Virgil C. Summer Nuclear Station (VCSNS) Units 2 and 3
Combined License Nos. NPF-93 and NPF-94
Docket Nos. 52-027 & 52-028

Subject: LAR 13-20 Request for License Amendment:
Module Obstructions and Details

LAR 13-20

Proposed Changes to Licensing Basis Documents

UFSAR Section 3.8, Figure 3.8.3-8, Sheet 1 of 3, [*Structural Modules – Typical Design Details*]* - Revise Tier 2* information in Note 2 to address acceptable spacing and tolerances.

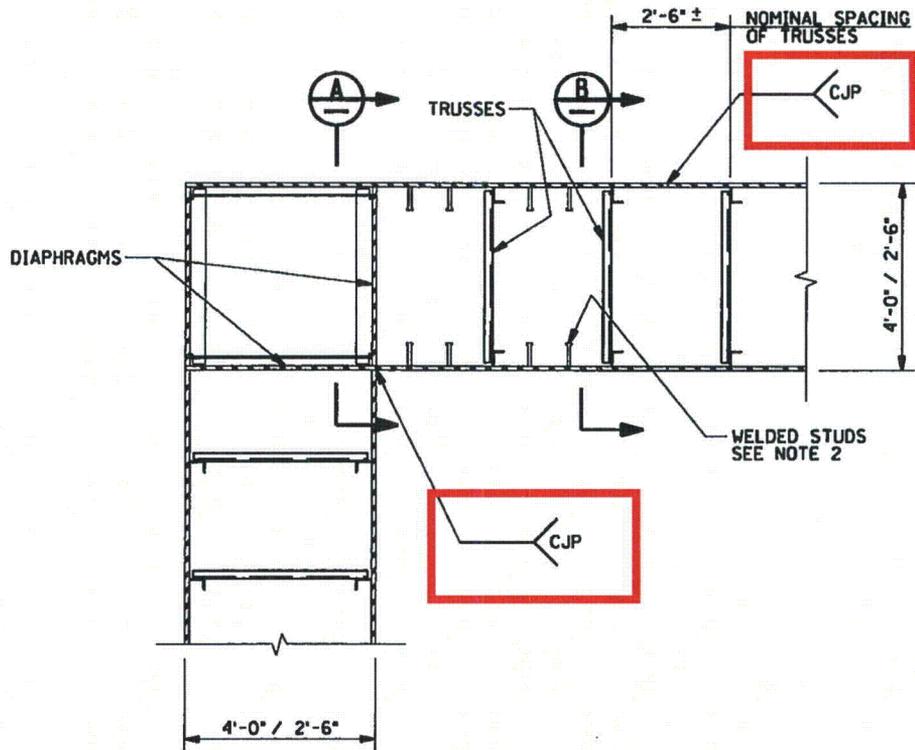
**2. DESIGN SPACING FOR WELDED STUDS IS SHALL BE SPACED AS FOLLOWS,
UNLESS OTHERWISE REQUIRED BY THE SPECIFIC
CODES AND STANDARDS INVOKED:**

THE TOLERANCE FOR THE SPACING IS \pm 10% OF THE DESIGN SPACING.

UFSAR Section 3.8, Figure 3.8.3-8, Sheet 1 of 3, [*Structural Modules – Typical Design Details*]* - Revise Tier 2* information in the Plan View Detail 1 to change weld symbols currently showing a square groove weld to a symbol indicating a Complete Joint Penetration weld.

$\frac{3}{4}$ " Φ x 6" @ 10" VERTICAL FOR A36 CS

$\frac{3}{4}$ " Φ x 6" @ 10" HORIZONTAL FOR A36 CS

$\frac{5}{8}$ " Φ x 6" @ 6" VERTICAL FOR SS

$\frac{5}{8}$ " Φ x 6" @ 6" HORIZONTAL FOR SS
